## Response to submissions – amendment report

Gregory Place Build-to-Rent

SSD-31179510 | April 2026

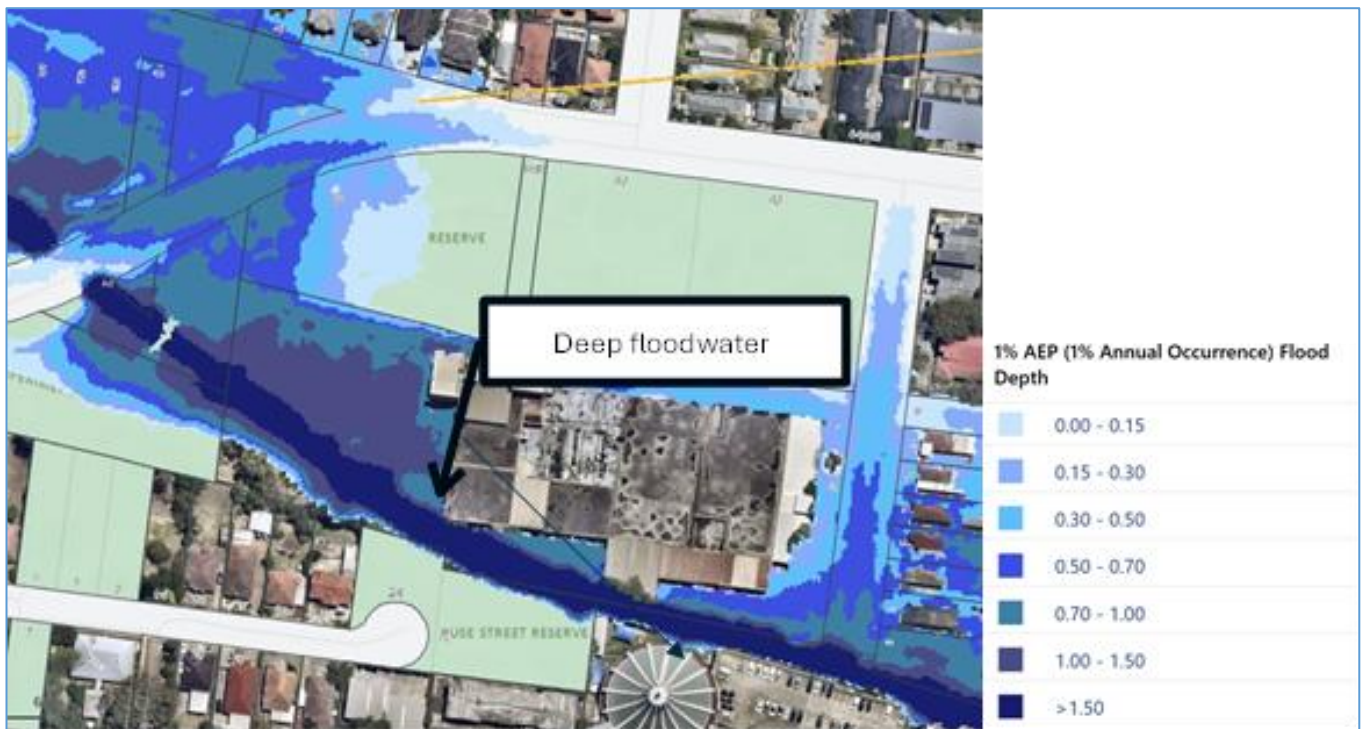
*c) The impact of extensive filling of the site within a floodplain*

*Council's flood study shows that to the west of the site there is a large area that is below the predicted 1% AEP flood level, with flood depths predicted of up to 1.5m (refer Figure 2). This is extreme hazard in a 1% flood and the proposal is to fill this area as well as other flood prone parts of the site. The filling of the site will result in a significant loss of large low-lying areas acting as flood storage. Any fill within the floodplain displaces floodwaters and causes adverse impacts on other properties. Council does not permit filling of the floodplain below the 1% AEP flood level. Clause 5.21 of the Parramatta LEP 2011 requires that the consent authority be satisfied that the flood behaviours will not result in a determinantal increase in the potential flood affection of other properties.*

6.1.1.31 Response C15

Council’s comment is unclear. It initially refers to large areas of flooding to the west, while the arrow in their figure 2 (above) points to the stormwater channel to the south of the site.

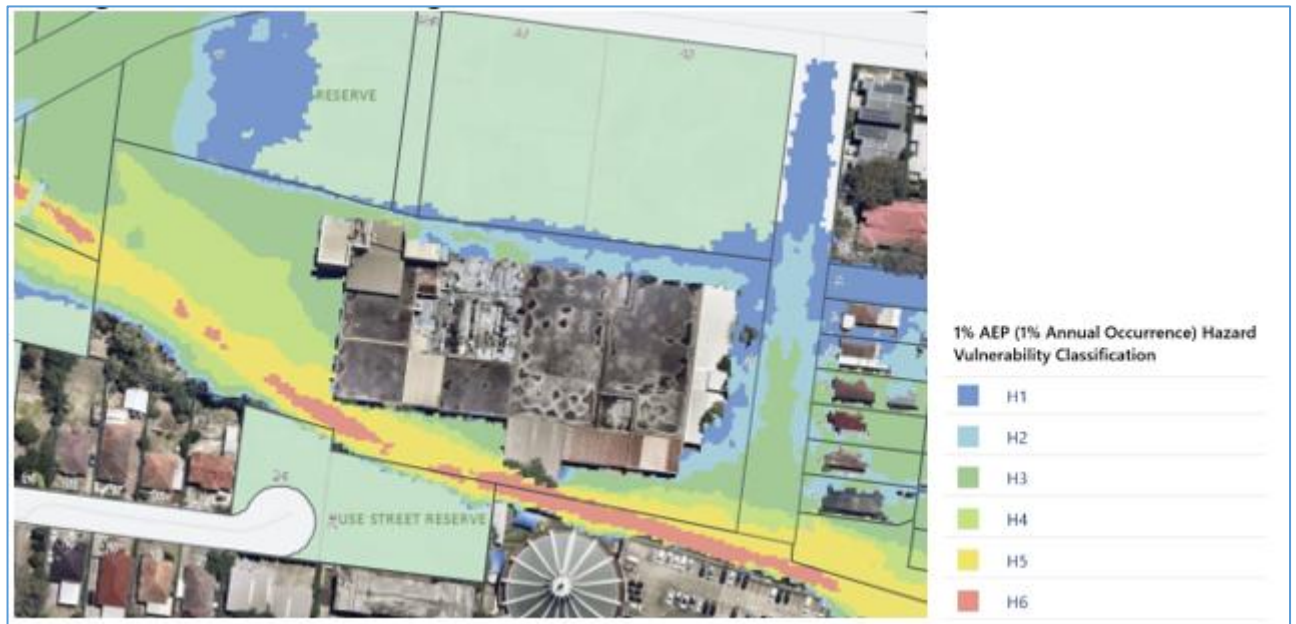
*Clay Cliff Creek passes across the site, partly contained in a concrete channel with estimated capacity 1 in 5 years (20%) AEP, but mostly conveyed across the site in an overland floodway. This is a significant flow, estimated between 28 and 40 m<sup>3</sup>/second. Council's 2024 Flood Study indicates this floodway and the impact of the existing buildings that are built across it. The wide floodway across the site, parallel to the concrete channel, is delineated by the H3-H4 Boundary in 1% AEP flood (refer Figure 3). The latest proposal severely obstructs this floodway and contravenes acceptable flood risk management practice and guidelines as set out in the NSW Flood Risk Management Manual as well as Council policies, planning controls and codes.*

#### 6.1.1.33 Response C16

Due to error in the PRFS model, flow upstream of the site were doubled in the PRFS model, leading to discrepancy in design levels and flows.

This has been raised in the Updated Flood Assessment, appendix O of the Amendment Report, acknowledged by Council in various parts of the catchment, and addressed in our response to item 1, key issues.

In the 1% AEP event, the site experiences only inundation along the southern boundary with low hazards mostly H1 and small areas of H2 as can be seen on the mapping provided in the Updated Flood Assessment.

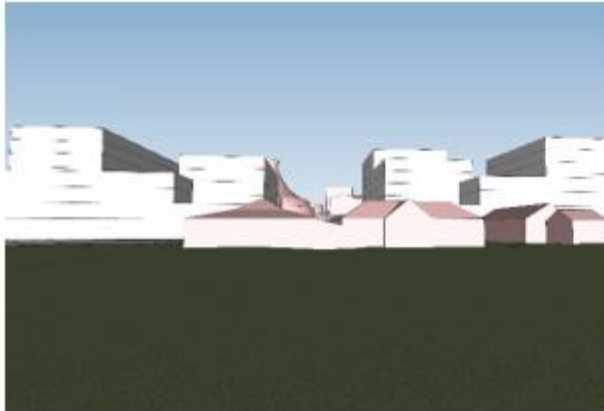
*highlights the relationship between Our Lady of Lebanon Co-Cathedral and the back of Hambledon Cottage. The different scales, styles and siting of the two buildings diminish the visible role and value of Hambledon Cottage. It also creates an inconsistent backdrop to Hambledon Cottage and reduces the opportunity for the development to provide a consistent backdrop to the cottage.*

The proposal sets out to establish what the author of this comment is seeking to prohibit, that is a more effective connection between Our Lady of Lebanon Co-Cathedral and Hambledon Cottage in the form of a longer distance vista through landscape as the predominant context for Hambledon Cottage.

The site exists within a vibrant neighbourhood and the proposal, as established in the project vision on page 2 of the Design Amendment Report, appendix C of the Amendment Report, reinforces the connection of community facilities and Hambledon Cottage in a landscape setting.

We note that the Heritage Council’s Approval’s Committee, and the State Design Review Panel both generally support the proposal, inclusive of the approach to massing taken by the proposal.

Furthermore, we refer to the Visual Impact Assessment, appendix F of the Amendment Report, and specifically comparative view 8 – Hambledon Cottage, page 85, which highlights the visual relationship between the sites, and identifies that the extensive vegetation on the skyline creates a greater impression on the perceived view, than anticipated when considering the landscape corridor in plan view.

Proposed scheme (Figure 4)

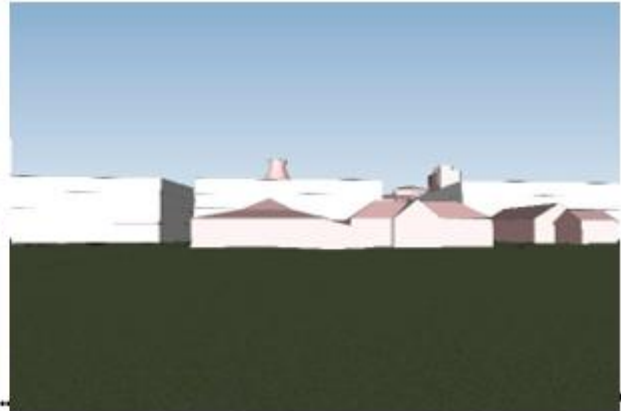
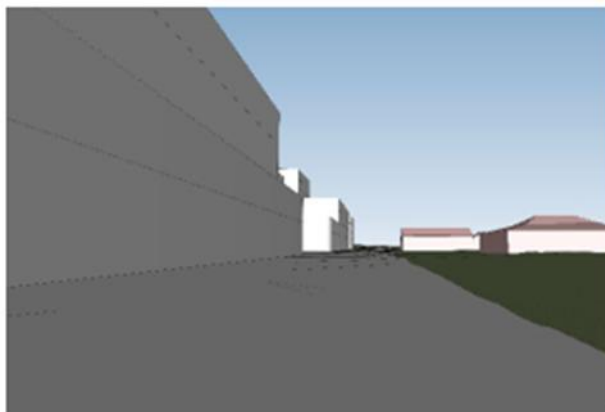
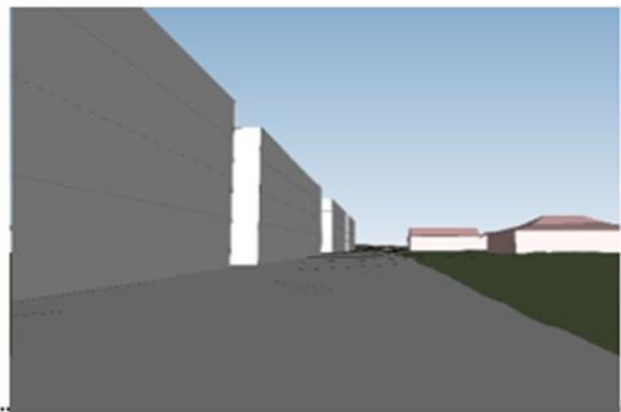
#### 6.1.1.76 Submission C38

*Recommendation: A simple, legible and consistent building height of four storeys should be applied throughout the development and the 30 metre visual link should be removed or reduced in width.*

Figure 4 shows The proposed scheme design (as modelled by Council) as viewed from Hambledon Cottage Reserve, with the Cottage in foreground. Figure 5 Council Officer’s recommended 4 storey scheme as viewed from Hambledon Cottage Reserve, with the Cottage in foreground.

Figure 6 Model of the proposed scheme design (as modelled by Council) as viewed from north-east boundary of site. Figure 7 Council Officer’s recommended 4 storey scheme design as viewed from north-east boundary of site.

The plan below shows the relationship of these important heritage sites and the site of the proposed development.

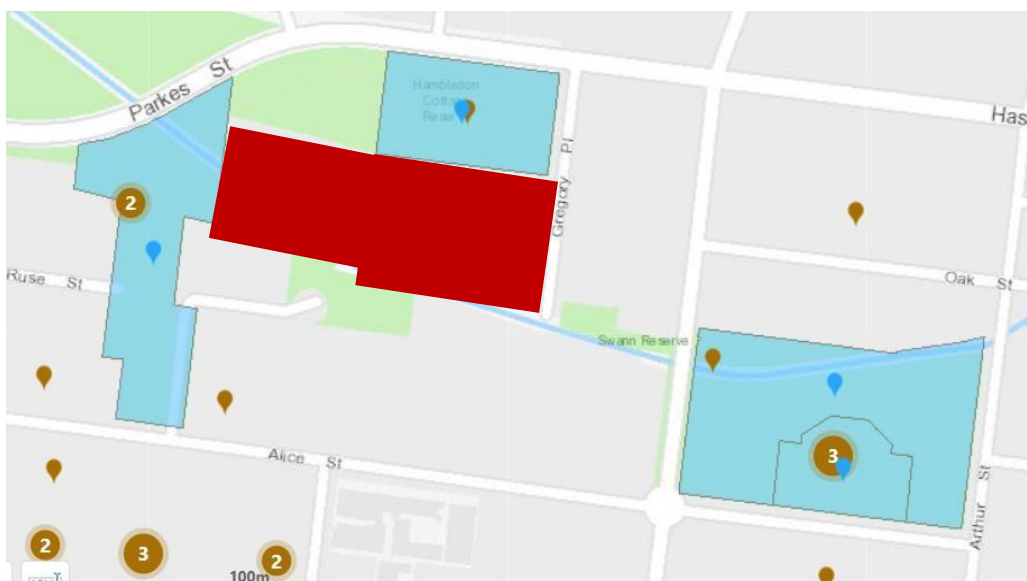
*These three important properties tell the story of British settlement in the colony of New South Wales. All three buildings and surrounds have been acknowledged as a large part of our heritage and remain in public ownership.*

*This Amended Development Application for build-to-rent dwellings site is in an extremely sensitive location midway between three significant historic houses in Australia, all listed on the NSW State Heritage Register and all in public ownership in recognition of their important cultural values.*

*Google maps view of 2A Gregory Place from Hambledon Cottage*

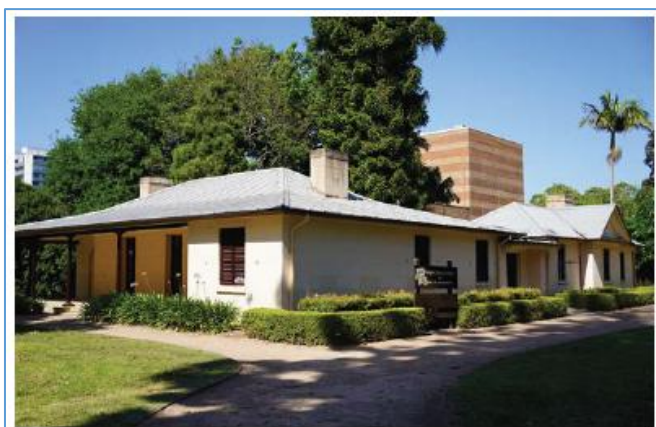
### 6.3.2.4 Submission PDHS2

*The Google Maps image below shows the present view of 2A Gregory Place from Hambledon Cottage car park entrance where visiting groups first enter the historic cottage grounds.*

*This view shows a low-density environment with a sparse level tree line with no concentrated development which harmonises with the heritage parkland.*
